Product Change Notice (PCN)

PCN Number: PCN-0456170R-01

Product(s) Affected: *PJ-031D*

PREVIOUS CUI DEVICES DETAIL / IMAGE	NEW CUI DEVICES DETAIL / IMAGE

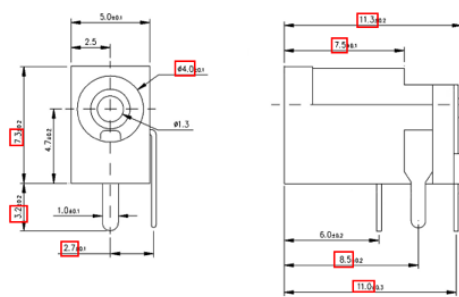
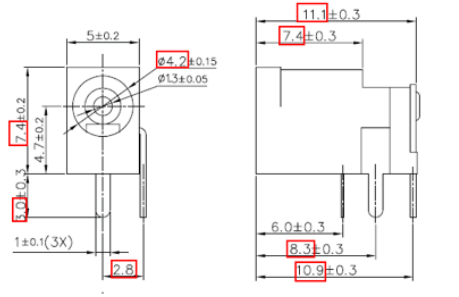
Description of Change: *Product re-engineered for improved manufacturability and production yield. See image below for product changes. Cosmetic differences may be visible and not affect the form fit and function of the product.*

<p>Recommended PCB Layout Top View</p>	 <p>Recommended PCB Layout Top View</p>

PREVIOUS CUI DEVICE'S DETAIL / IMAGE			NEW CUI DEVICE'S DETAIL / IMAGE		
DESCRIPTION	MATERIAL	PLATING/COLOR	DESCRIPTION	MATERIAL	PLATING/COLOR
center pin	brass	silver	center pin	brass	CuSn
terminal 1	brass t=0.50	silver	terminal 1	brass t=0.40	silver
terminal 2	MM alloy t=0.20	silver	terminal 2	stainless steel t=0.20	silver
terminal 3	brass t=0.50	silver	terminal 3	brass t=0.40	silver
housing	PA10T (UL94V-0)	black	housing	PA10T (UL94V-0)	black
<p>MATING PLUG Jack Insertion Depth: 7.0 mm</p>			 <p>MATING PLUG Jack Insertion Depth: 6.2 mm</p>
